National Rivers Authority South West Region

MICRO LOW FLOWS AVERAGE AND LOW FLOW ESTIMATION IN THE S.W. REGION VALIDATION OF VERSION 1.1 SOFTWARE

> July 1991 WR/91/2 Water Resources

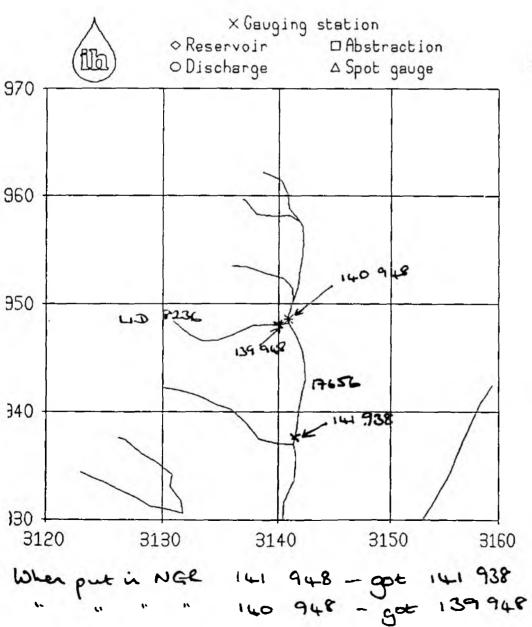
MICRO LOW FLOWS VERSION NO. 1.1 DATE 30 L PC No. 381M 191 TEST NO. N.G. R. Texter COMMENT eq. Test ran smoothly. Results shown in maps and tables incorrect. Found the testing instructions difficult to follow. This was a test I did on the River Sid in hydrometric area 45. When I put in the NGR given by Micro Las Flows for the required stretch it chose a different stretch will a slightly different NGR. There didn't seen to be any reasoning behind it. Thus has also happened i other hydrametric areas.

Erme - rendom test

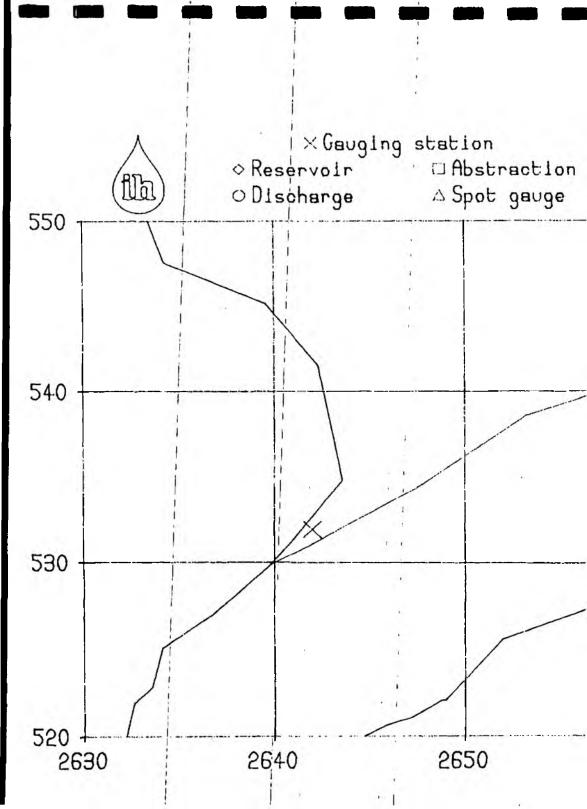
MICRO LOW FLOWS ERROR REPORT Ref. No. 8 Version No. PC NO. 381M Date 10 4.41 Identified during test? Yes No National Rivers Authority If Yes, Test No. Kindom. South West Region Name of tester A Summary of problem R. Erne - gauging station shown (see attached plot.) appears to be situated between two over reaches. The formation for this gauged station can't be obtained by chosing eather of these stretches. Impact Assessment (circle as appropriate) А в C D Ε Reported to IoH (All A, B & C errors) Date 25 491 1991 ModeMai Reply 191 1991 Date 5 Mode Ma Sign Please refer to accompanying notes when completing this form Monley House **Kestiel Woy** Exeter Devon EX2 710 Tel: Exeter (0392) 444000 Fax: (0392) 444238

COMMENT SHEET (To be filled in following the successful completion of a scheduled test. Please use separate error reporting form for specific errors/problems.) MICRO LOW FLOWS VERSION No. 1.1 DATE PC No. 381M TEST NO. Landom. COMMENT eg. Test ran smoothly. Results shown in maps and tables incorrect. Found the testing instructions difficult to follow. When error 8 was first reported it seemed that the information relating to Emington Gauging Station could not be obtained by selecting either of the rearby stretches. It now seens that the information can be obtained but it depends an where you position the nouse. If you choose a point at the bottom of the stretch you cannot obtain the information but if you choose a point further upstream you can There doeon't seen to be any explanation as to why this is the case.

exe -test7notepsd

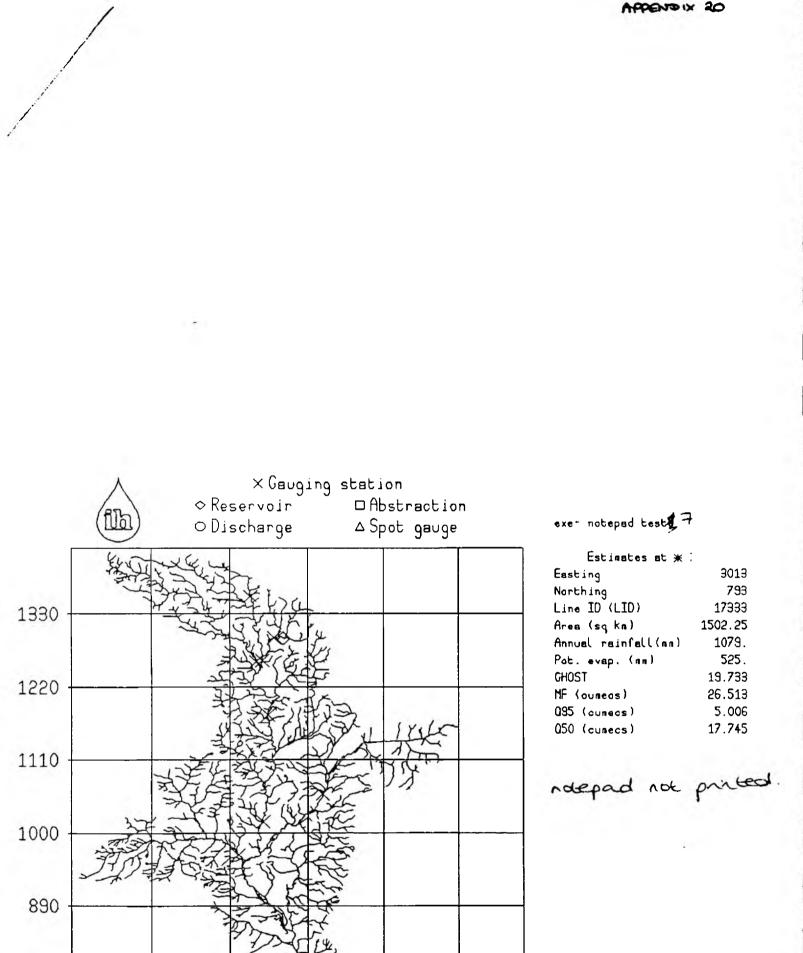
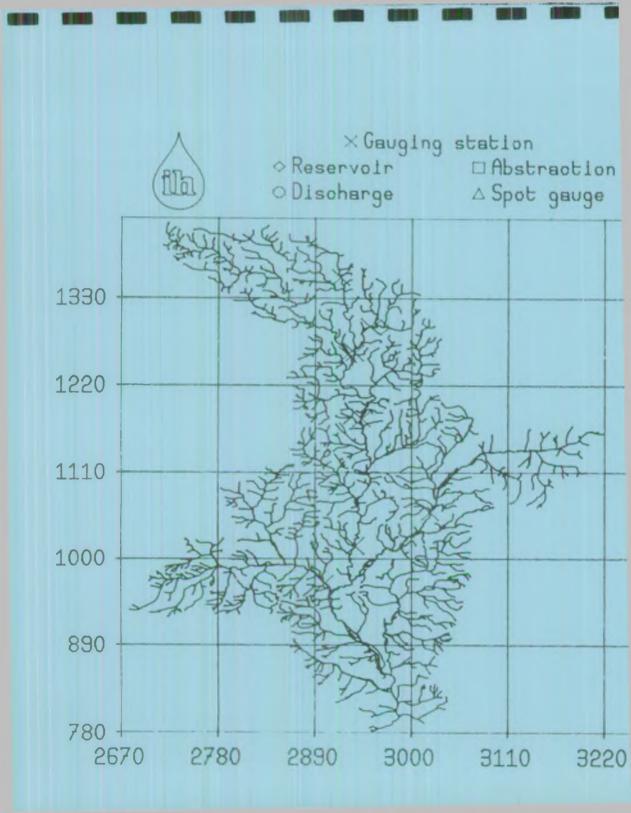
TEST NO. 7
